# Access Compliance Report

## Public Rights-of-Way

### (Curb Ramps)

Intersection ID: N/A	Main Street: BRYANT_FARMS_RD	Cross Street: KINGSTON_FOREST_DR	Location: SW
ADA ID: 3D86C021D30F	Ramp Type: PerpDiag	Initial Pass/Fail: Pass	Overall Compliance: No
		Severity Score: 0

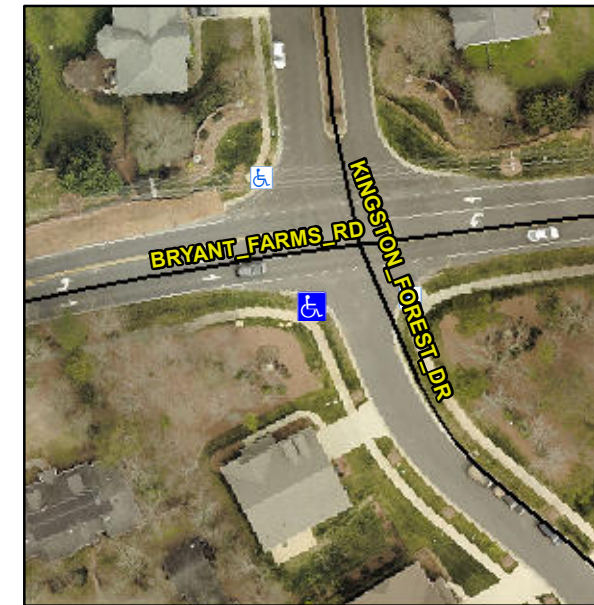
**R305.2**

**Remove & Replace Detectable Warning System.**
